Bald Mountain Interdisciplinary Team
High Sierra Range District
29688 Auberry Road
Prather, CA 93651

Re: Comments on the draft environmental assessment for the Bald Mountain Project

These comments are submitted on behalf of Sierra Forest Legacy. We have reviewed the draft environmental assessment (EA) and various specialist reports. We found that the document suffers from a number of violations to the National Environmental Policy Act (NEPA) and National Forest Management Act (NFMA). We provide details of our review below, but more generally we find:

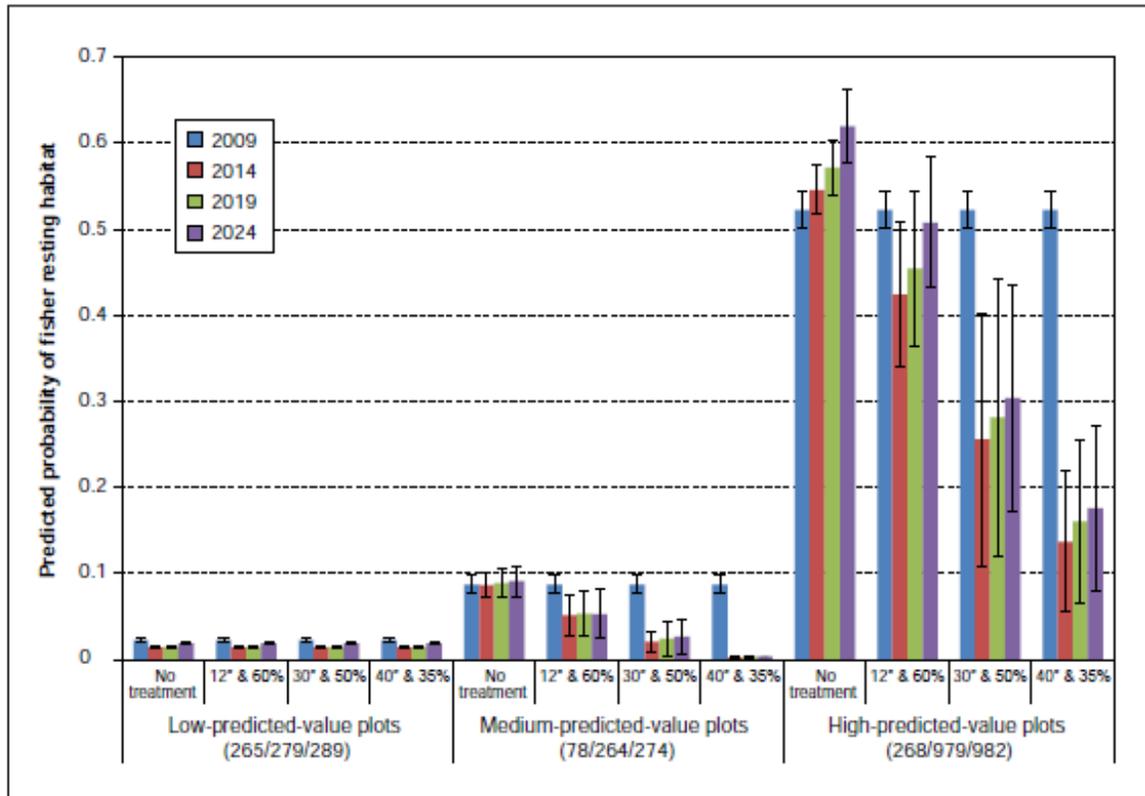
Results from a second study also conflict with the claims of “recovery” made in the BE. Thompson et al. (2011) examined modeled changes in home range conditions following simulated treatments and a period of growth. This study found that for an attribute like canopy cover that pre-treatment conditions were not achieved for at least 30 years. Both of these assessments suggest that the claims in the BE that habitat will recover within 15 years cannot be supported. These studies indicate that assumptions in the BE would lead to an under estimate of treatment effects. The BE should be revised to reflect these studies and the conclusions about effects adjusted accordingly.

This idea of recovery is embedded in the effects analysis presented in the EA for both CSO and fisher and used to characterize the effects of the project as minimal. Please revise the effects analysis to reflect a longer recovery period and reassess the conclusion about significance of the short term habitat changes.
